Commonwealth Edison Company  
Byron/Braidwood Units 1 and 2  
Relaxation of MSSV Setpoint Tolerance to +/-3% - Revised SECL

Enclosed please find Revision 1 to safety evaluation SECL 90-469, previously transmitted via Reference 1. The revised safety evaluation clarifies the section of the ASME code associated with the main steam safety valves.

WESTINGHOUSE NUCLEAR SAFETY  
SAFETY EVALUATION CHECK LIST

APPENDIX B  
UFSAR MARKUPS

Figure 2.

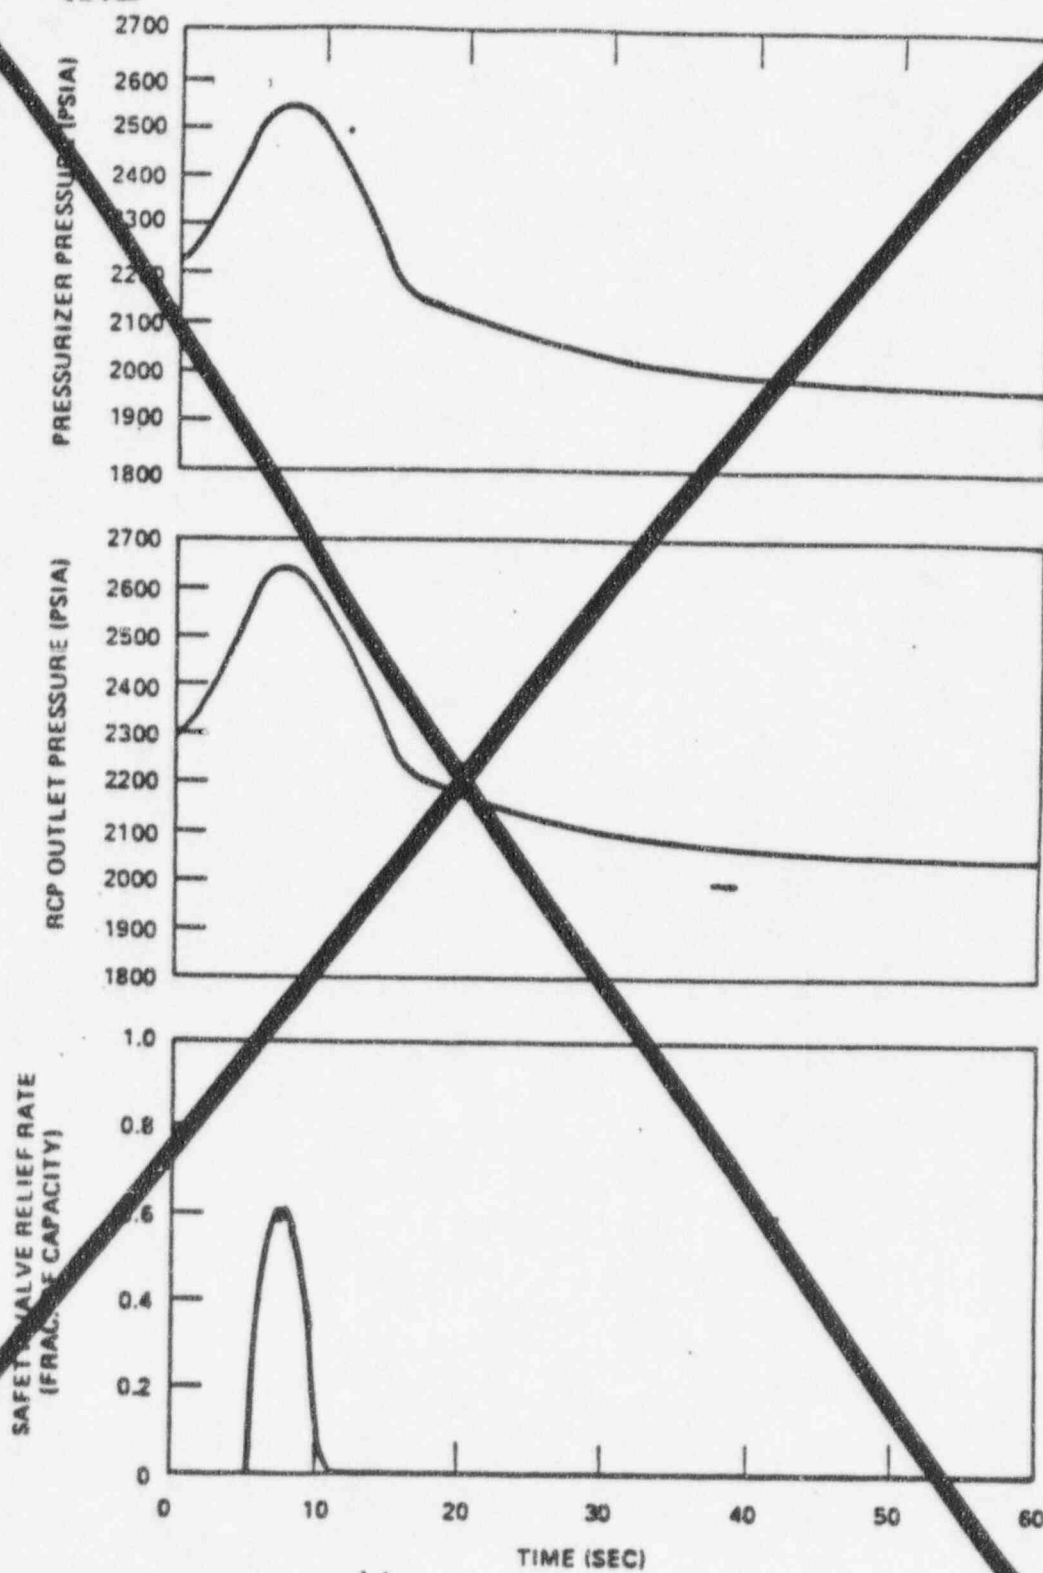
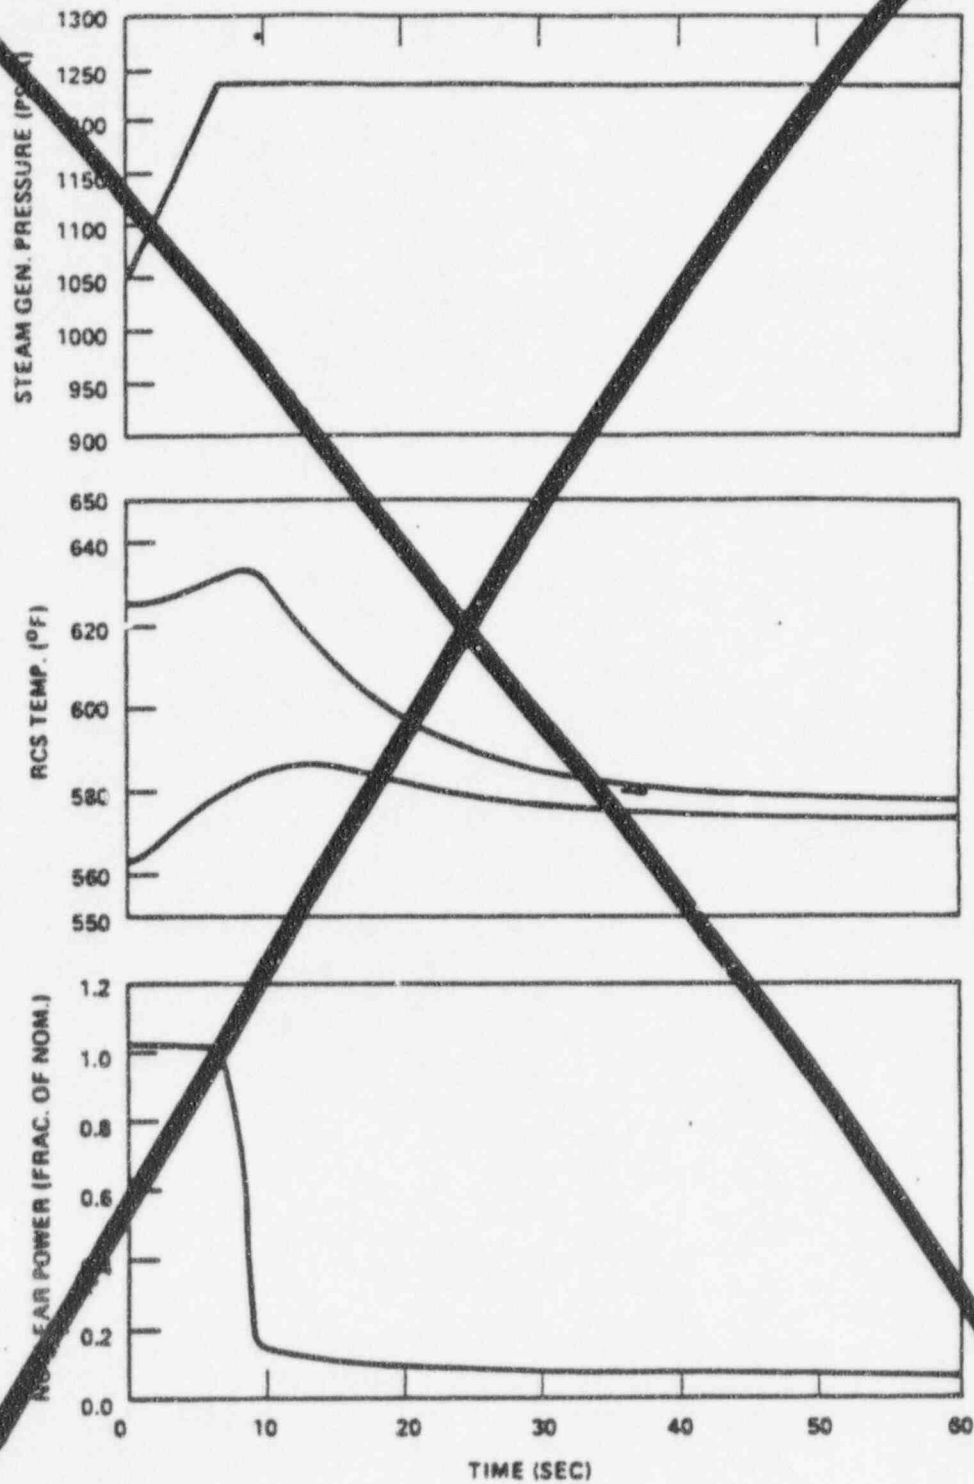
The results of the Turbine Trip transient are shown in Figures 2 and 3. Figure 2 shows the pressurizer pressure, the reactor coolant pump discharge pressure, which is the point of highest pressure in the RCS, and the pressurizer safety valve relief rate. Figure 3 shows steam generator shell side pressure, reactor coolant loop hot leg and cold leg temperature, and nuclear power. The reactor is tripped on a high pressurizer pressure signal for this transient.

Replace with  
the following  
Figure.

FIGURE 3

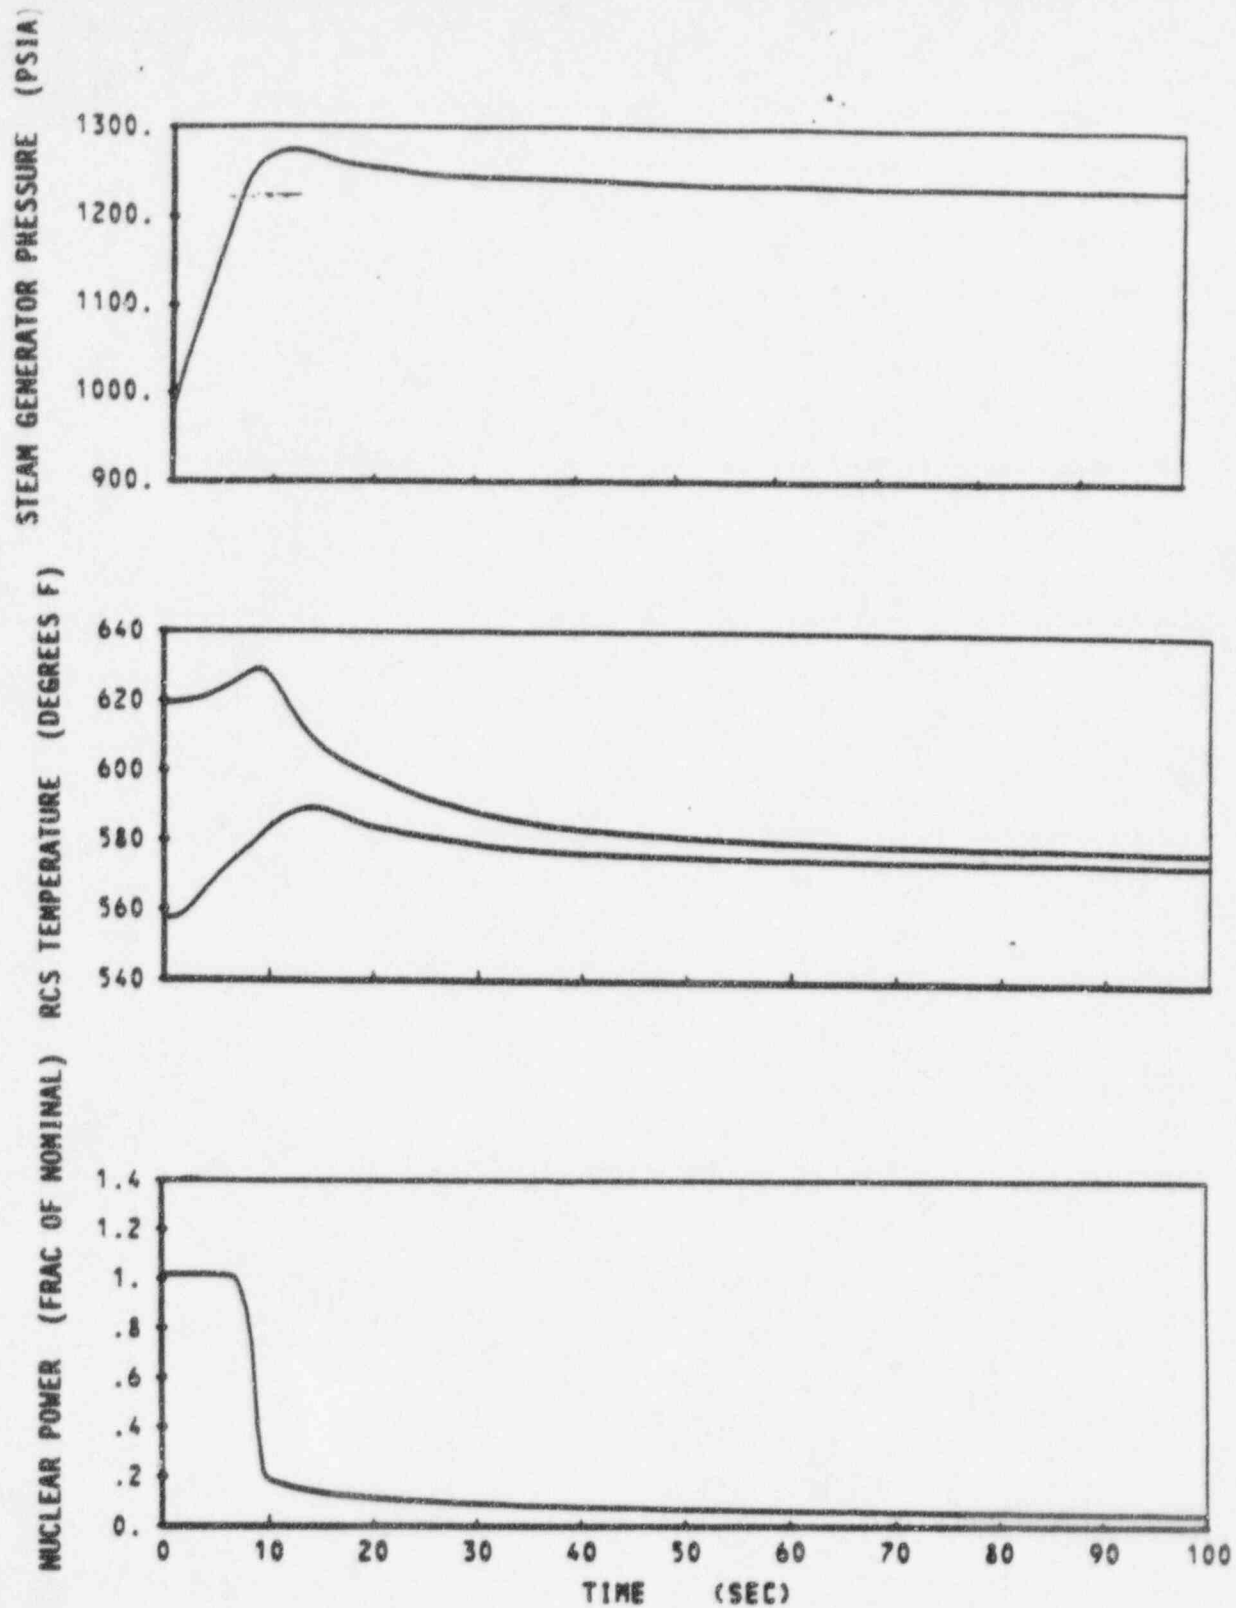
Replace with  
the following  
Figure.

Figure 15.0-1

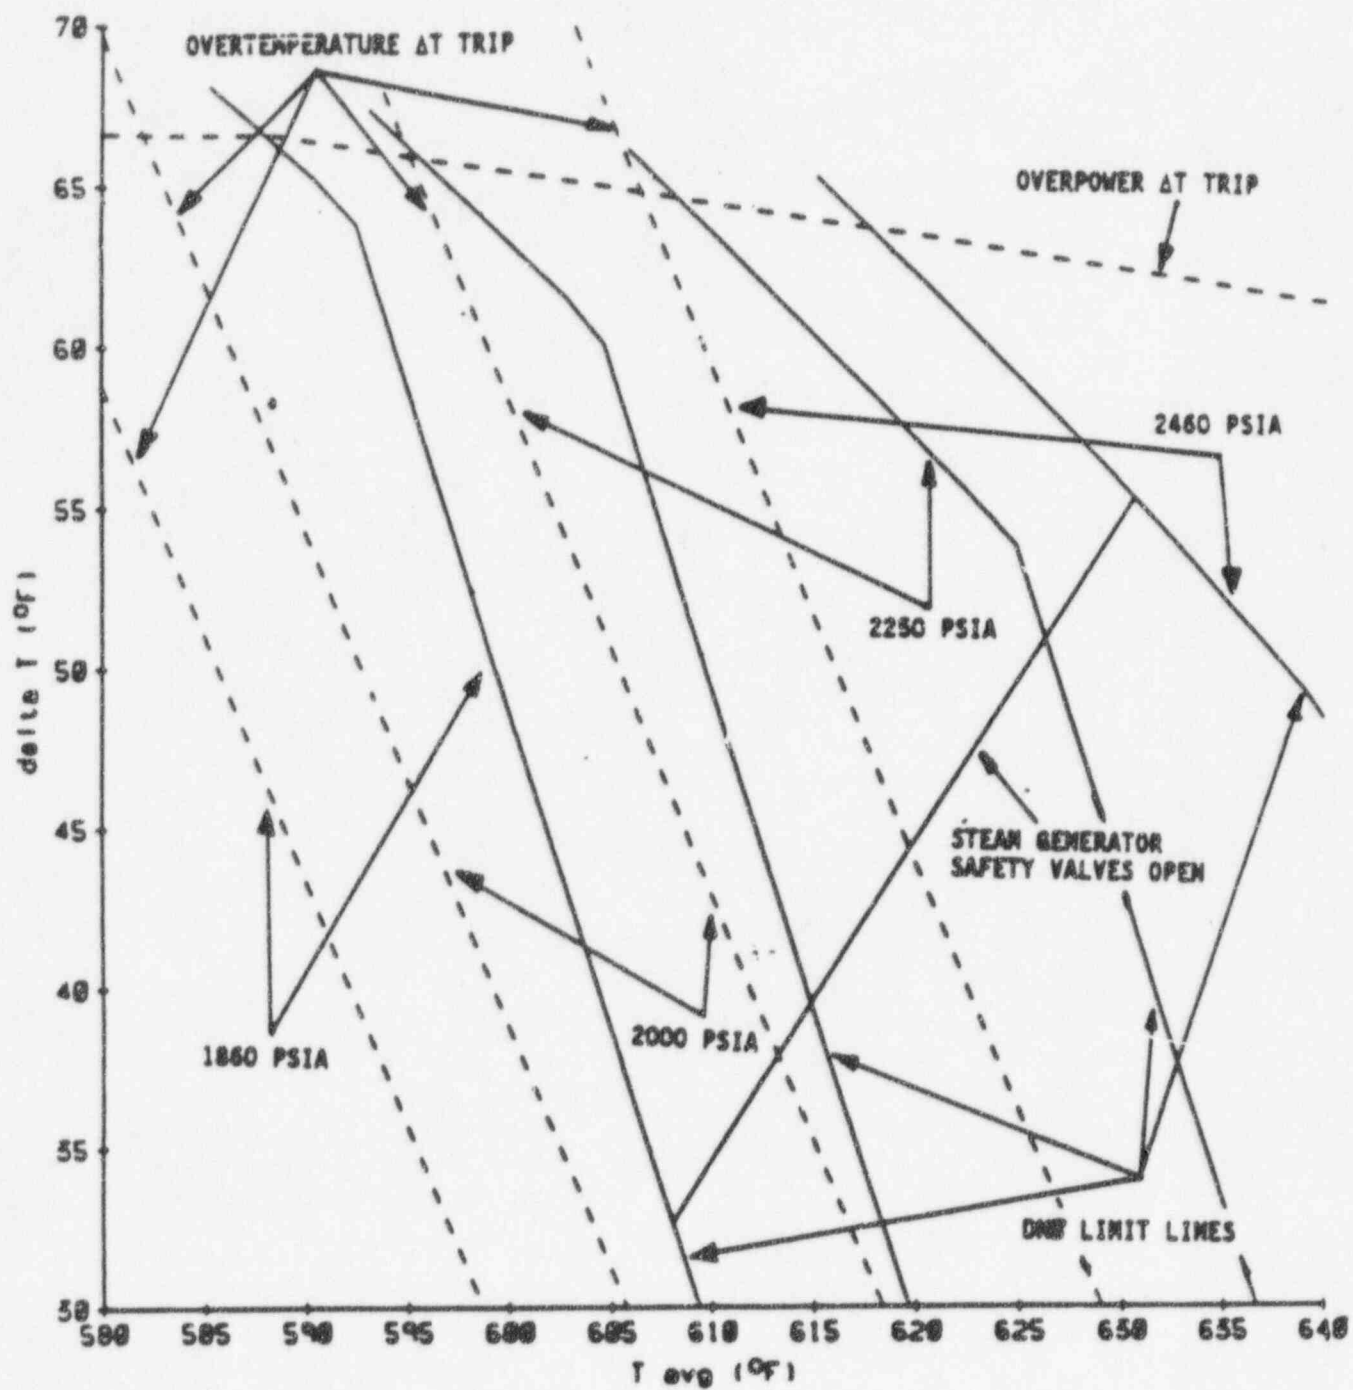
The increase in the MSSV lift setpoint tolerance has the potential to impact the Overtemperature  $\Delta T$  and Overpower  $\Delta T$  setpoint equations. Referring to UFSAR Figure 15.0-1, increasing the point at which the MSSVs lift will lower the steam generator safety valve line. If the current OT $\Delta T$  setpoint coefficients (K1 through K3) result in protection lines that just bound the thermal core limits, it is possible that by lowering the SG safety valve line to the right, a portion of the core limits will be uncovered.

In order to evaluate the effects of the increase in the setpoint tolerance, the Overtemperature  $\Delta T$  and Overpower  $\Delta T$  setpoint equations (K1 through K6) were examined to determine if the equations remained valid assuming that all 20 MSSVs opened with a +3% tolerance. The results of that evaluation showed that there was sufficient margin in the generation of the current setpoint equations to offset the lowering of the SG safety valve line. The results of this calculation are presented as Figure 1.

REPLACE WITH  
The following  
Figure
